A D D E N D U M 1

DATE: September 23, 2026
TO: All Bidders
FROM: Trevor Butler
Purchasing Agent
RE: Invitation to Bid #26-0930 Garrett County Administration Building Sidewalk Project

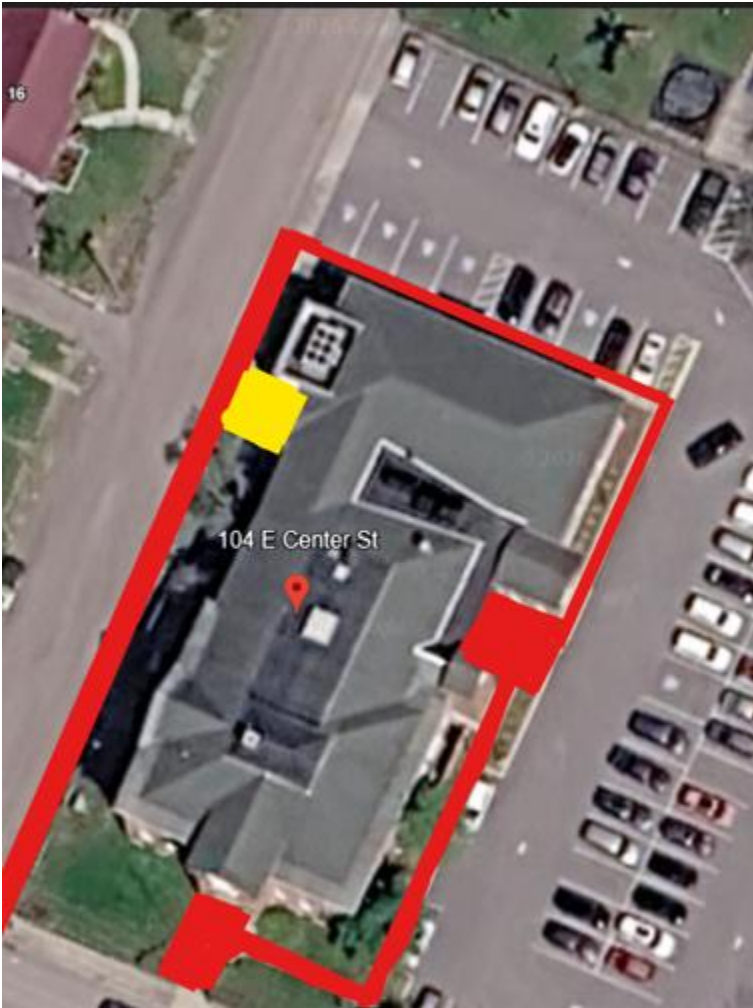
6. Area highlighted in Yellow was added to the scope of replacement at 104 E. Center Street (Community Action) location.
